Addendum to Environmental Impact Report

Addendum Date: **April 12, 2017**
Case No.: **2011.0123E**
Project Title: **Peninsula Pipelines Seismic Upgrade Project**
EIR: 2011.0123E, certified October 17, 2013
Project Sponsor: San Francisco Public Utilities Commission
Lead Agency: San Francisco Planning Department
Staff Contact: Chelsea E. Fordham – (415) 575-9071
Chelsea.Fordham@sfgov.org

Figure 4: Alignment of Segment 4 (shown in red)

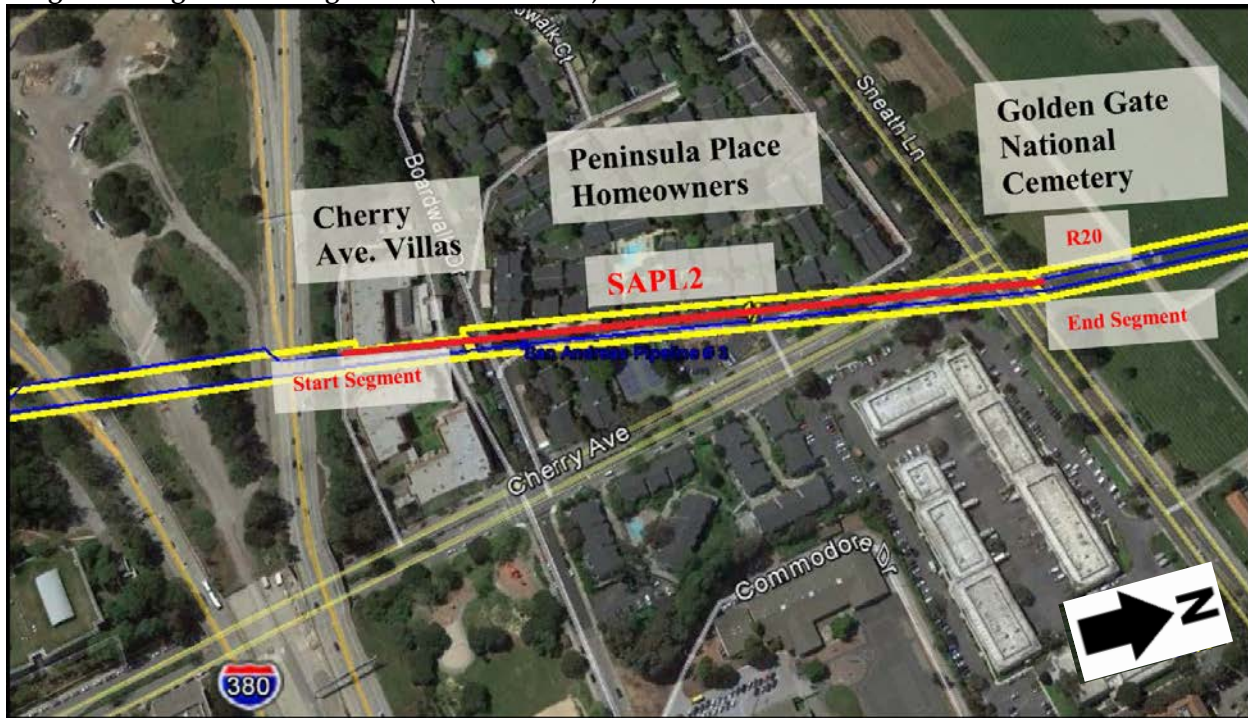
Construction of segment 4, within the Cemetery would also include supporting the existing fence in place while the existing pipe is removed and a new pipe is slipped under the fence. Additionally, all landscaping that is impacted by the project in the cemetery will be replaced in kind. Figure 4, below, shows the alignment of the existing SAPL2 segment to be replaced.
